APPEAL APPLICATION

Re: <u>Appeal of Central Area Planning Commission Approvals for the HPMC Building Project (Case No. APCC-2020-1764-SPESPP-SPR, Environmental Case No. ENV-2015-310-MND-REC1)</u>

We write on behalf of Coalition for Responsible Equitable Economic Development Los Angeles ("CREED LA") to provide preliminary comments on the HPMC Building Project ("Revised Project"), including the Addendum ("Addendum") to the October 2015 Initial Study/Mitigated Negative Declaration ("IS/MND") prepared by the City of Los Angeles ("City") for the Revised Project. A different version of the Project, the Virgil Avenue Parking Structure Project, was originally approved by the City in 2015 in reliance on the October 2015 IS/MND ("Approved Project"). These comments are submitted in accordance with the Central Area Planning Commission's ("Commission") Rules and Operating Procedures Rule 4.3(a). CREED LA reserves the right to submit additional comments and evidence

But the Addendum's claim may be inaccurate. Figure 1, below, is a Google Earth photo of the Approved Project, as constructed. Figure 1 shows that the

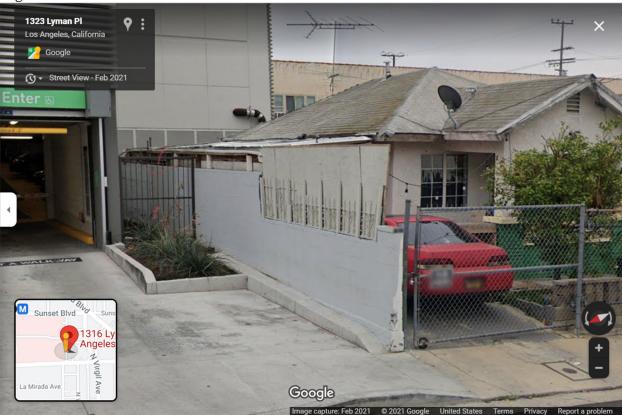
parking structure's entrance is close to an adjacent single-story residence at 1316 Lyman Ave, Los Angeles. Figure 1 also shows that the wall is not a decorative masonry wall, and is not 6 feet tall through its entire length. It appears that the residents of 1318 Lyman Ave needed to supplement this wall with plywood. It is unknown whether this makeshift barrier was intended to reduce the Project's aesthetic impacts or the significant noise impacts from parking structure entrance. It is also unknown whether the Project Applicant has improved this wall since the date of the February 2021 photo. Nonetheless, the City must consider the possibility that the parking structure's noise impacts on neighboring sensitive receptors are yet unmitigated. Further increases in noise from the Revised Project may exacerbate these impacts. A subsequent or supplemental EIR must be prepared to analyze these impacts.
